Determination 2008/4

Relocating and re-using safety barriers in the alteration of existing bridges on Fitzgerald Avenue, Christchurch

Figure 1: The existing safety barriers

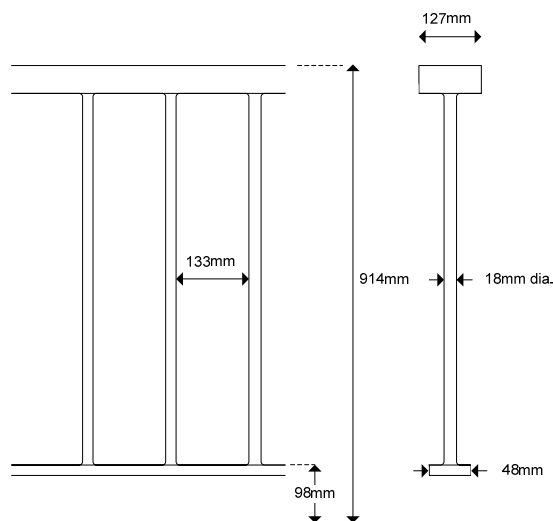
- 2.1 The two bridges were constructed in the 1960s. They are side by side, oriented north-south, and carry a main road across a river. The alteration consists of widening each bridge to provide an additional lane on its eastern side. For each bridge, the widening will require the existing footpath and barrier on the eastern side to be relocated to the new eastern edge of the bridge. The owner proposes to re-use the existing eastern barriers, and to make no alterations to the other barriers. Approximately 30% of the total length of all the bridges’ barriers would be relocated.
- 2.2 All barriers are of steel construction, 914 mm high with top rail 127 mm wide, no intermediate horizontal members, and a clear opening between vertical balustrade members of nominally 133 mm (refer Figure 1).

5.4.2 One way of complying with those provisions of the Building Code is to comply with paragraph 1.2.3 of F4/AS1 by altering the relocated barriers to have a height of 1,100 mm instead of 914 mm, and to have a top rail no more than 75 mm wide instead of 127 mm.

5.4.6 I conclude, therefore, that the relocated barriers with a height of 914 mm and a top rail width of 127 mm would not comply with the Building Code as an alternative solution.

- (a) The relocated barriers must be upgraded to comply with the Building Code.
- (b) The barriers that are not being relocated need not be upgraded but if the owner chooses to alter them then they must comply with the Building Code.

Figure 5: Parapet and rail barriers
Paragraph 1.2.3

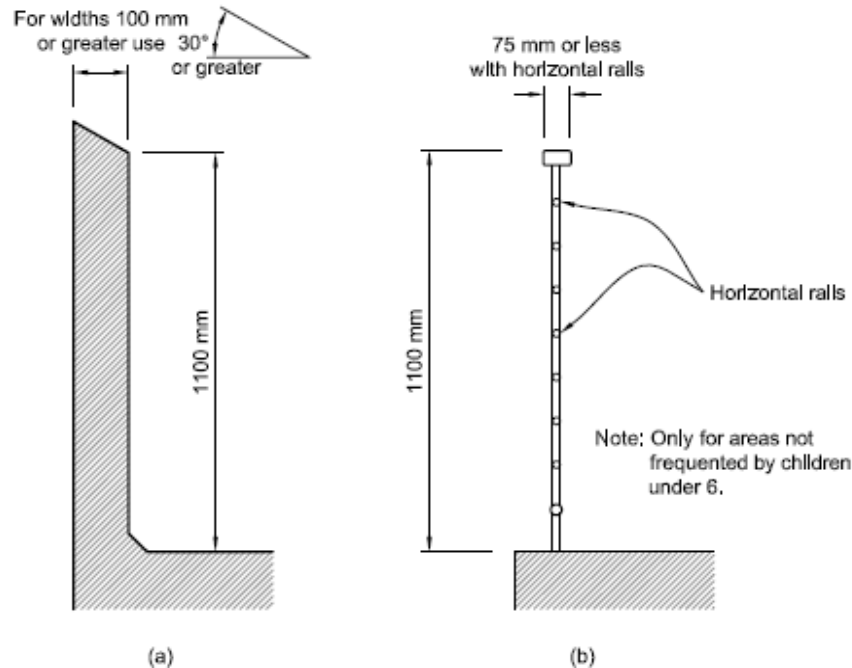
- (b) As to the width of the top rail, I consider that the F4/AS1 maximum width of 75 mm was introduced in 2007 when Clause F4.3.4(g) was added to the Building Code. That clause is not limited to any particular types of buildings or any particular circumstances. Accordingly, I take the view that I cannot take account of whether the bridges concerned represent less than the worse case contemplated by F4/AS1 because Clause F4.3.4(g) applies to all cases. In this case, therefore, the owner’s point that a person could well stop to admire the view but is unlikely to sit on the barrier is irrelevant and the relocated barriers must be constructed so that they are not readily able to be used as seats.
